CHANGE ORDER

PROJECT: Williamson County Justice Center Renovations
405 Martin Luther King Drive
Georgetown, Texas 78626

CHANGE ORDER NO: 001

DATE: June 25, 2021

ENLARGED
NEW CONSTRUCTION
PLANS - POWER

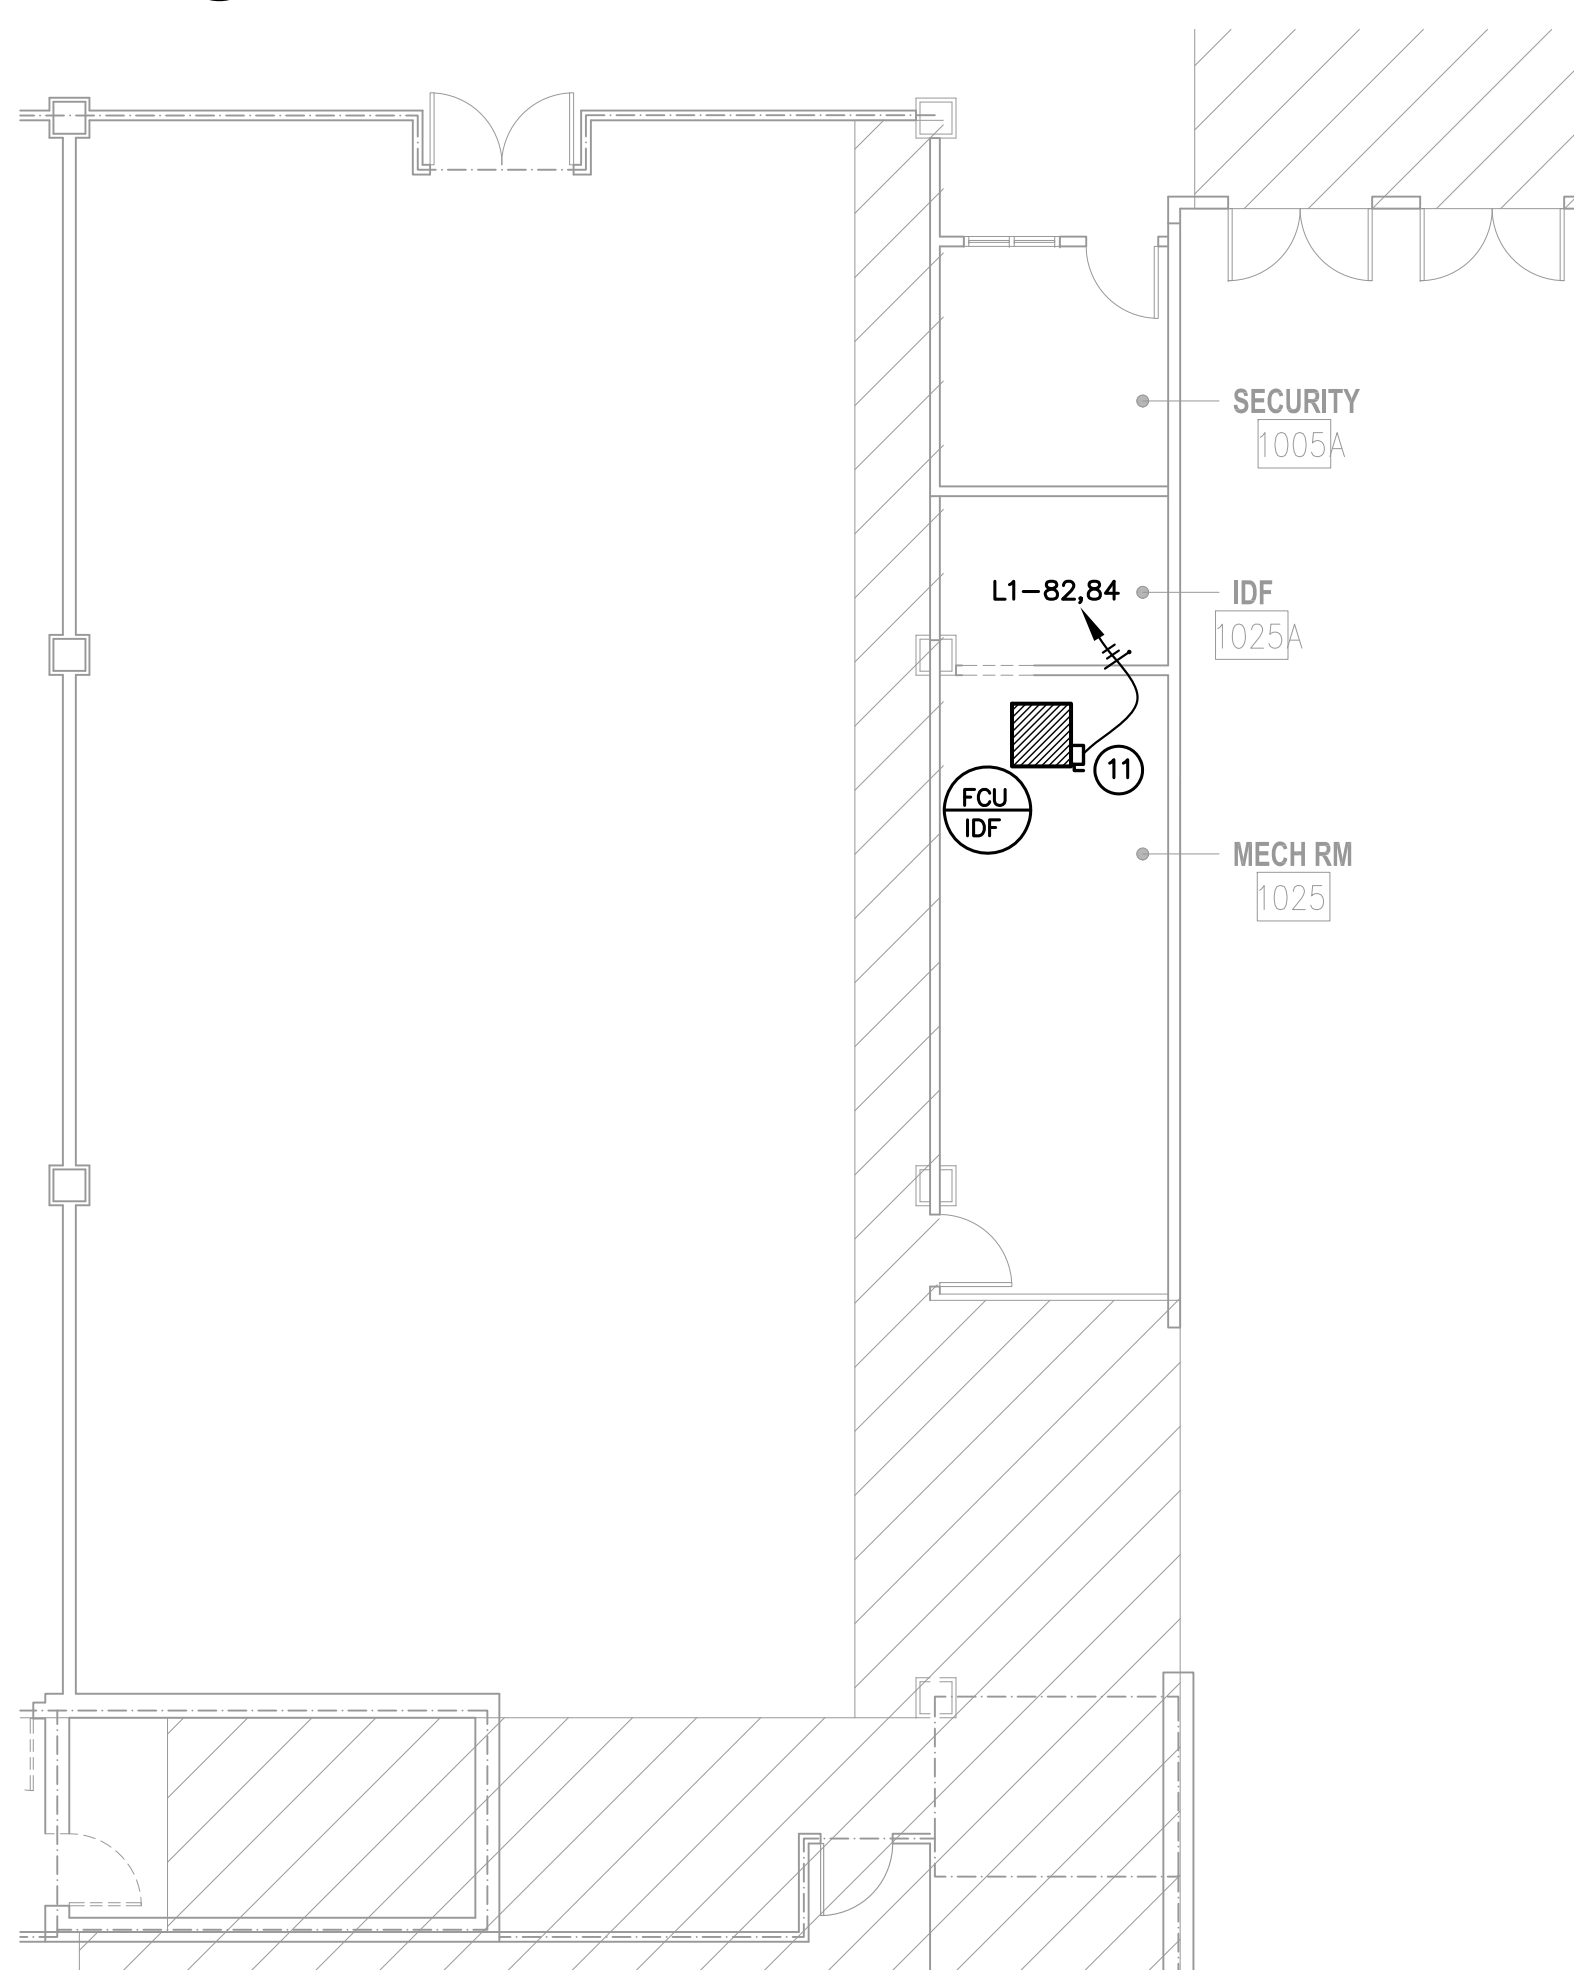
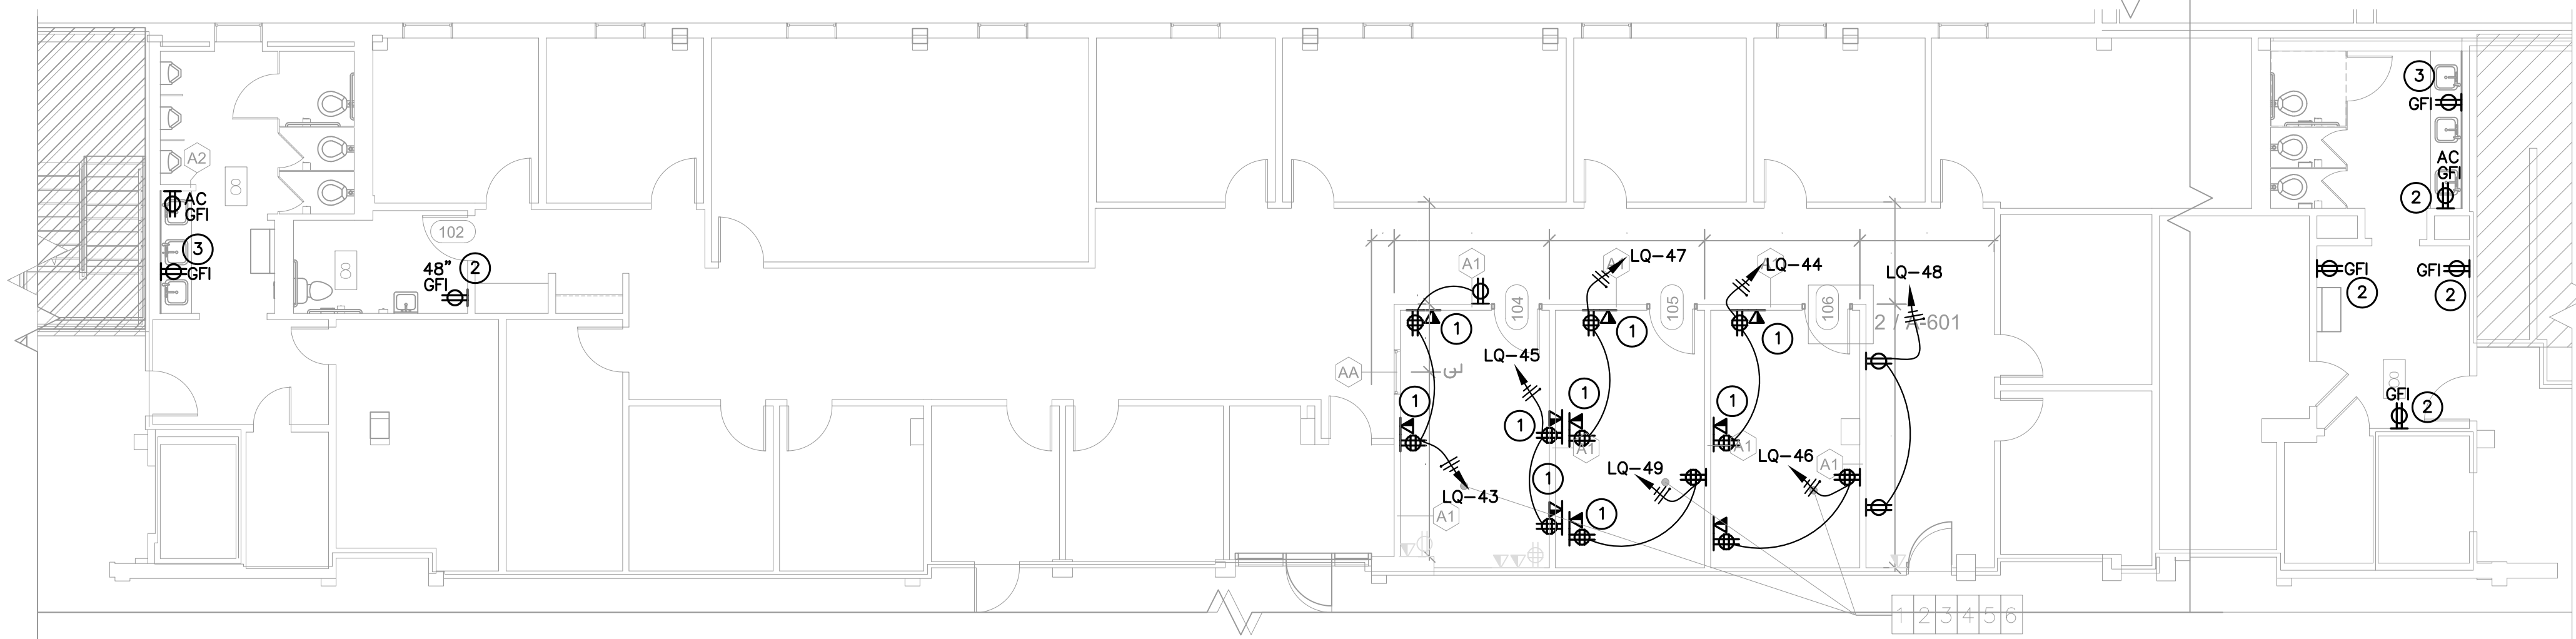
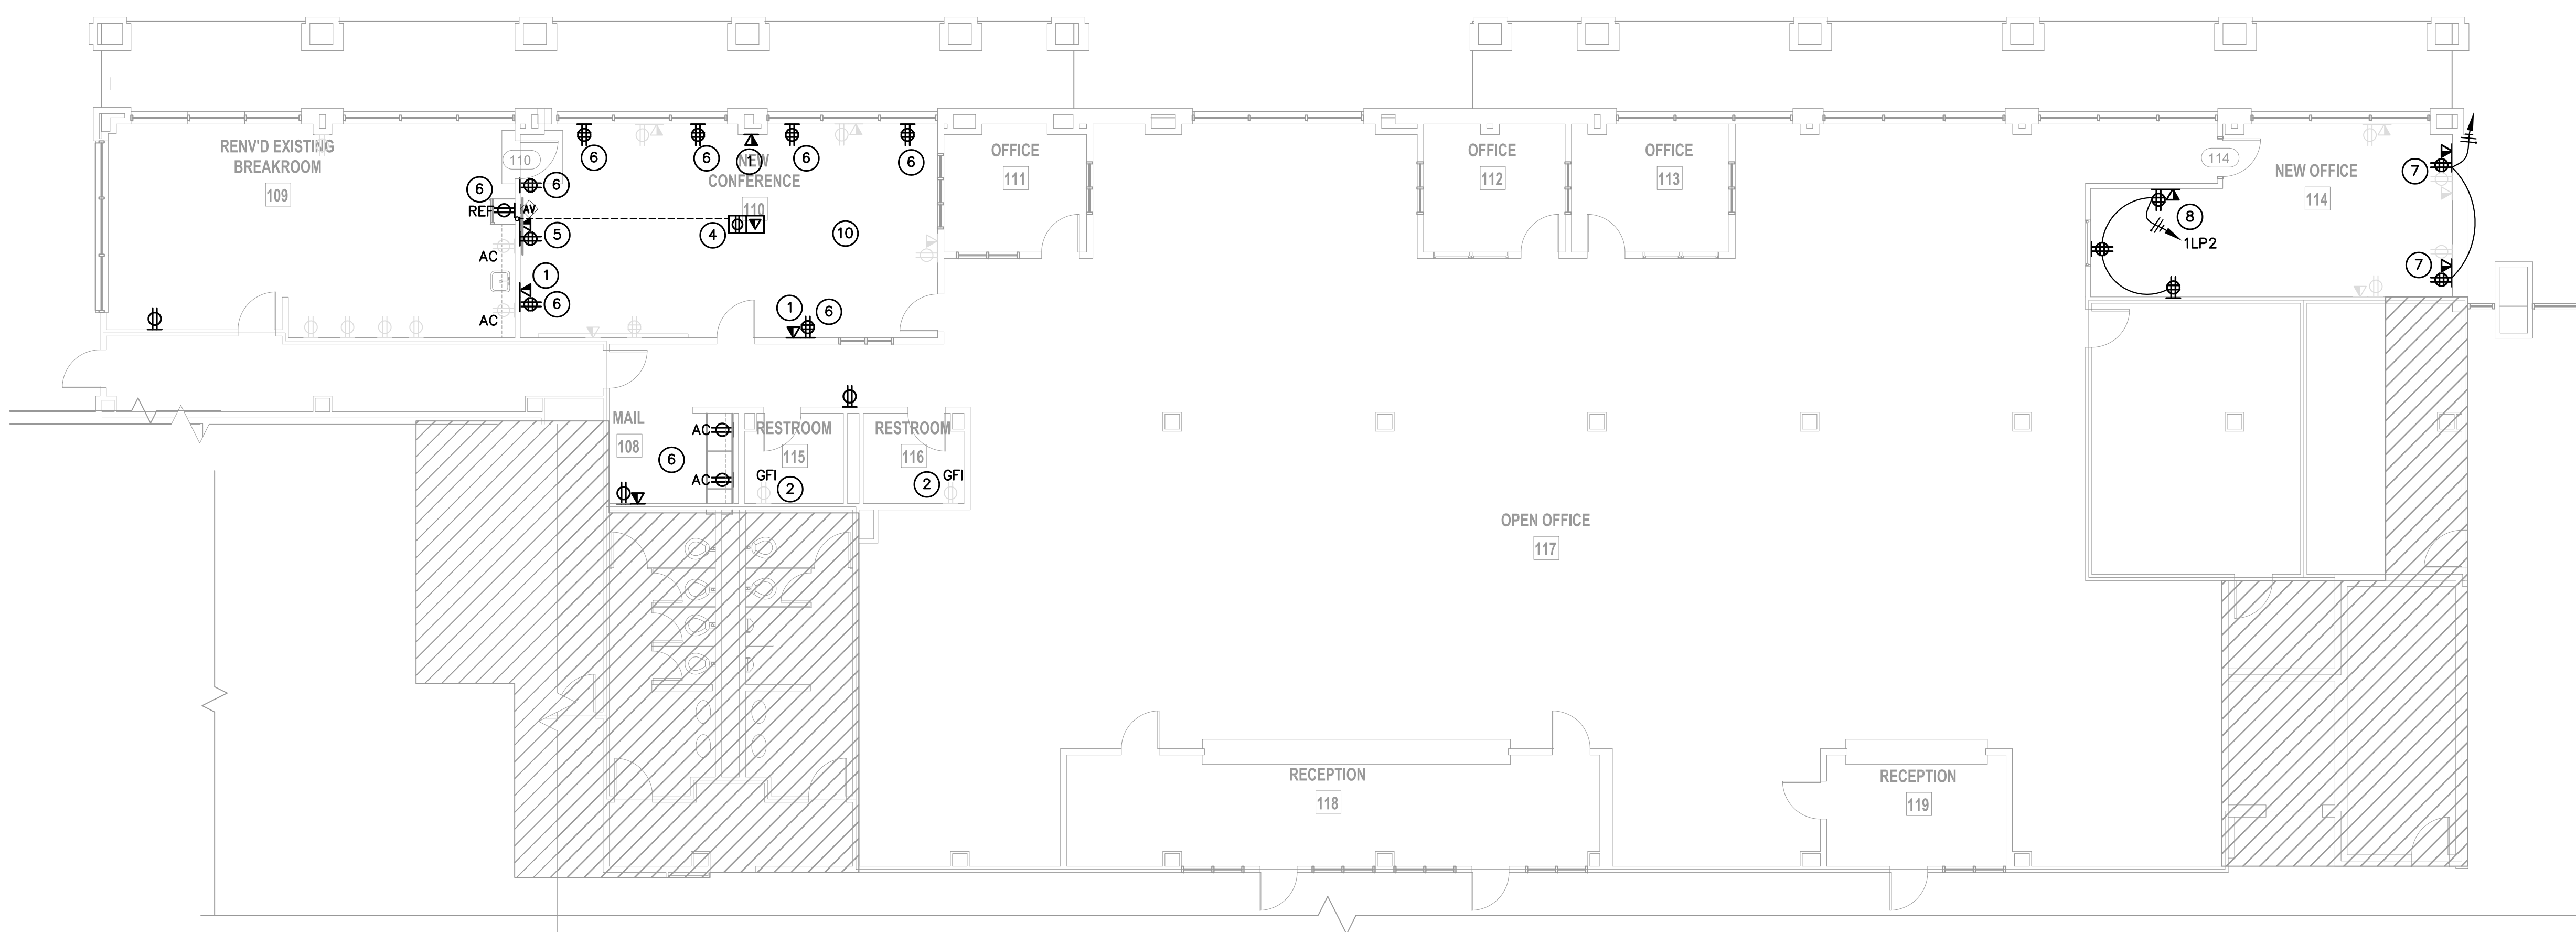
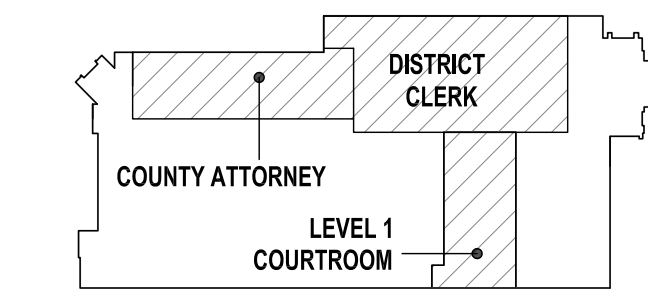
Provide dedicated circuit to panel L1 for refrigerator
receptacle

Provide dedicated circuit from emergency panel LE1 on the roof to new court room doors

- 10 ADDITIONAL A/V REQUIREMENTS FOR THIS ROOM. REFER TO A/V DRAWINGS FOR EXACT ROUGH-IN REQUIREMENTS. PROVIDE ALL EQUIPMENT AS NECESSARY.
- 11 PROVIDE NEW 30A/2P/NF/N1/HO/240V DISCONNECT FOR NEW FCU-IDF. CIRCUIT TO PANEL 'L1' AS SHOWN WITH 2#10 & 1#10 GND. IN 3/4" CONDUIT.

- 12 PROVIDE ELECTRICAL CONNECTION FOR NEW ELECTRONIC SECURITY DOORS. VERIFY EXACT REQUIREMENTS WITH DOOR SYSTEMS VENDOR. CIRCUIT TO EMERGENCY PANEL 'LE1' AS SHOWN WITH 2#10 & 1#10 GND. IN 3/4" CONDUIT.

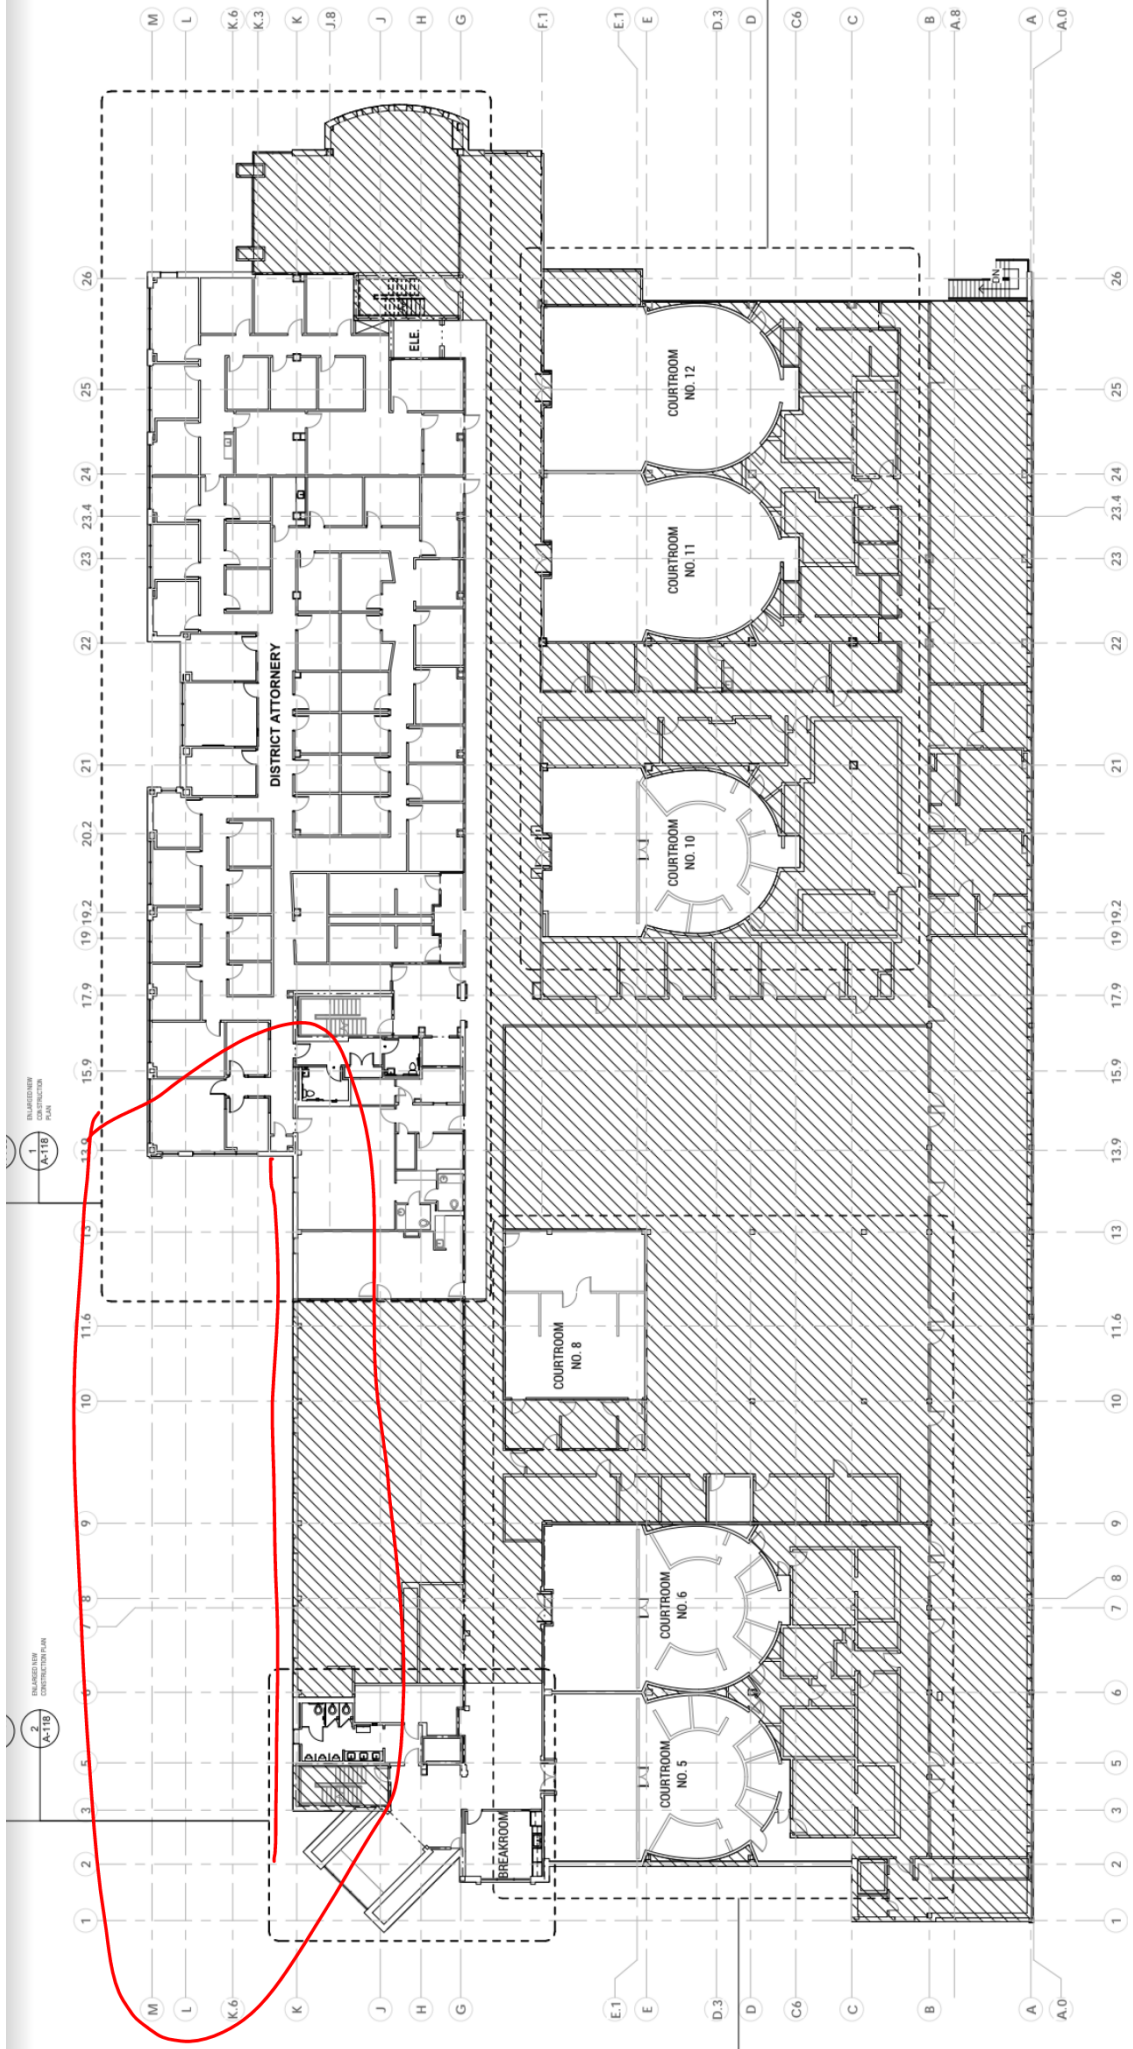
A DETAIL INSPECTION WAS PERFORMED AND WE FIND SEVERAL COLLAPSED AND BLOCKED AREAS IN THE EXISTING LINE.
REMOVE AND REPLACE EXISTING S.S. LINE IN THE WEST SIDE OF THE BUILDING AS SHOWING IN THE ATTACHED PLAN.
